RECALL CAMPAIGN 17V-088: CHECK TANK VENTILATION LINE AND REPLACE IT IF REQUIRED I01 REX

I01 (i3 REX)

RE: Recall 17V-XXX: Fuel Tank Vent Line B13 01 17

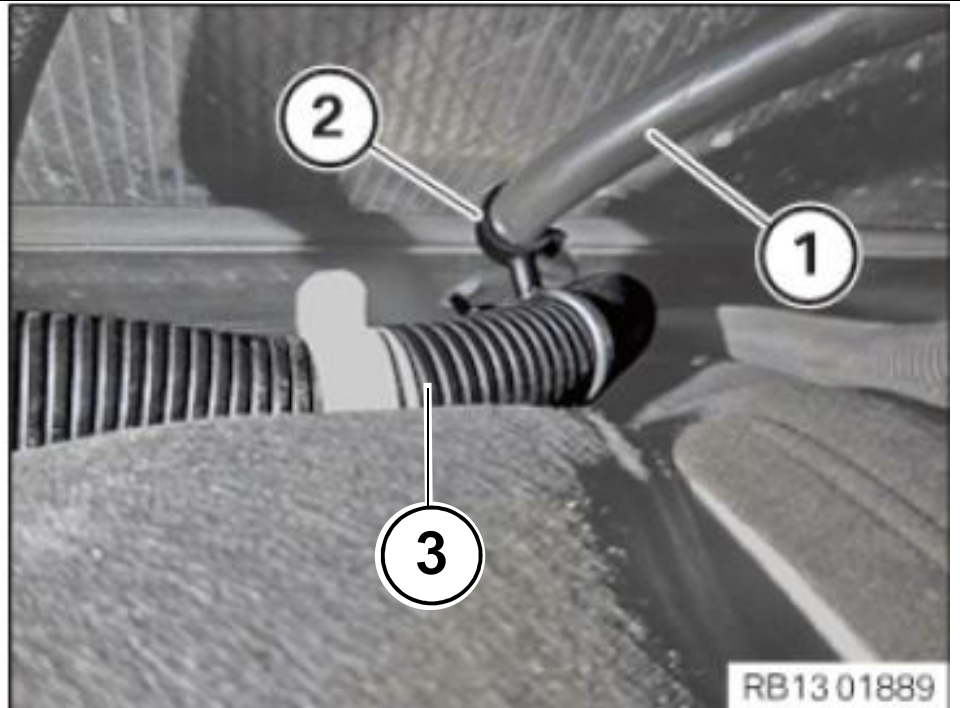
6. Once the tank ventilation line has been inspected or replaced, install the cable strap with holder (2). Secure the cable strap with holder (2) to the B+ cable (3) and to the tank ventilation line (1). Ensure that the tank ventilation line (1) engages audibly on the holder (2).

Ensure that the distance (a) between the cable strap with holder (1) and the B+ cable metal clip (2) is 40mm.

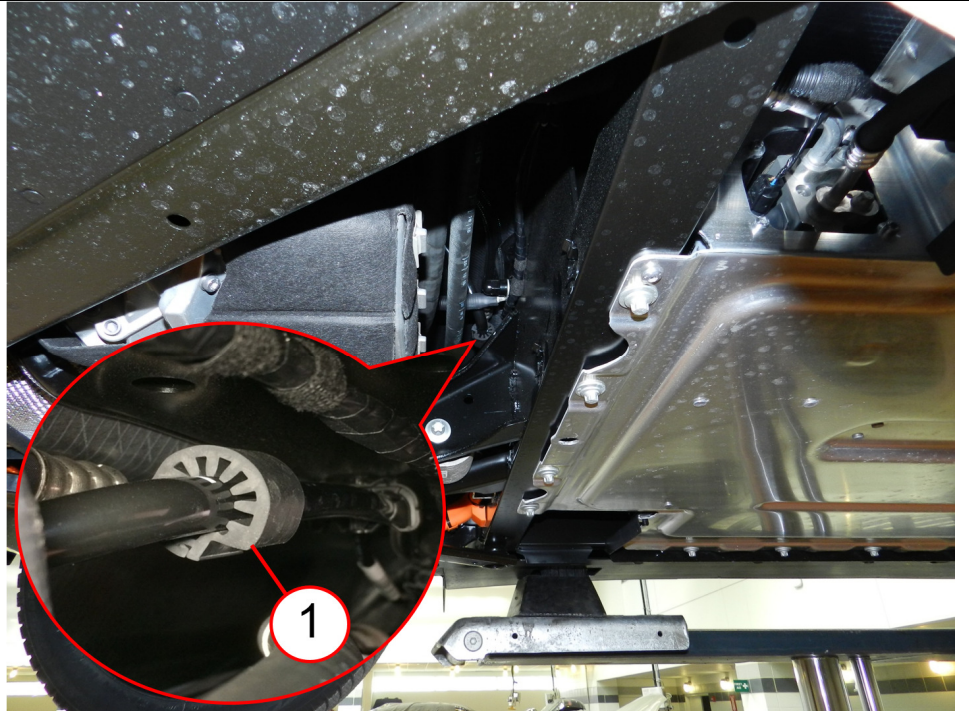
7. Verify that the abrasion protection (1) is installed on the tank ventilation line.

If the abrasion protection (1) is not installed, it must be retrofitted.

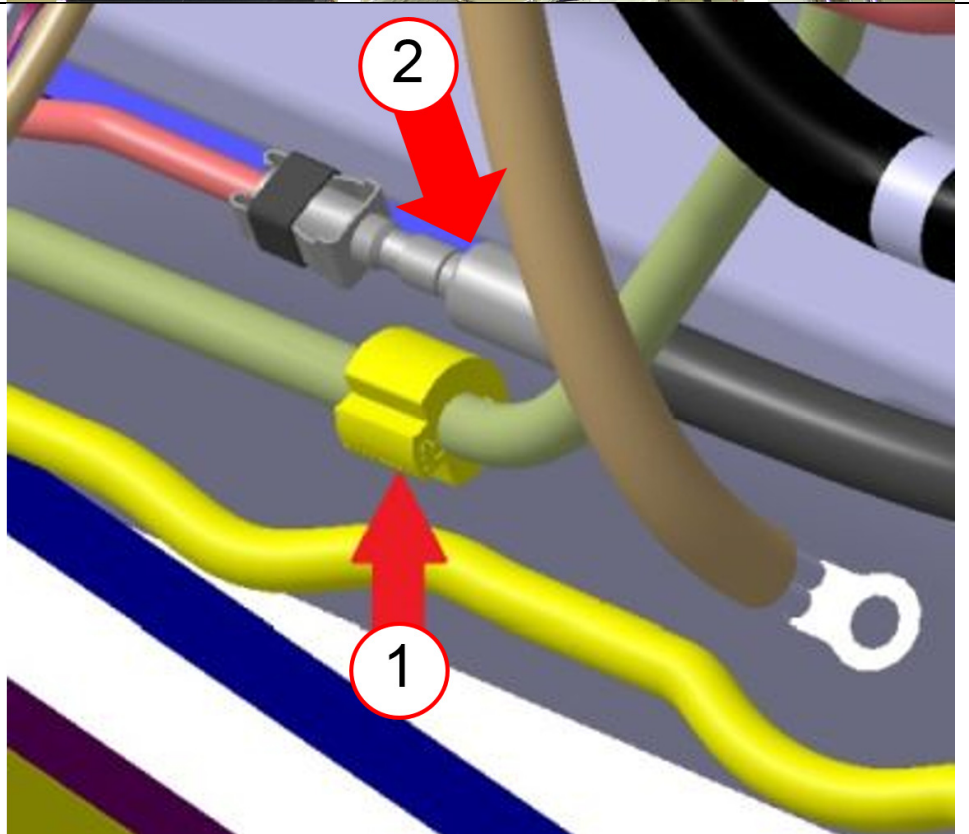
8. Secure the new abrasion protection (1) on a suitable position on the tank ventilation line, so that it protects from any contact between the tank ventilation line and the fuel feed line (2).

Note: The abrasion protection (1) is already preassembled on the new tank ventilation line and does not need to be retrofitted when replacing the tank ventilation line.

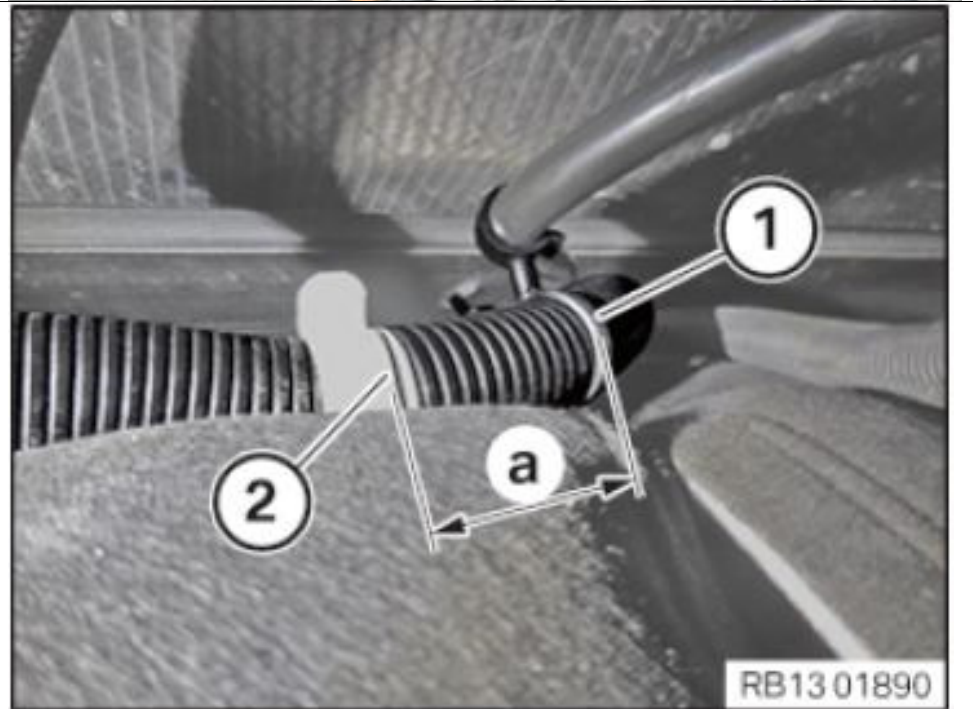
Verify that the tank ventilation line (2) is not in contact with the metal clip of the B+ cable (1). If there is no contact, Proceed to step 11.

10. If there is contact between the above mentioned metal clip and the tank ventilation line, recheck the installation of the cable strap with holder (1) and ensure that the distance (a) between the cable strap with holder (1) and the B+ metal cable clip (2) is 40mm.
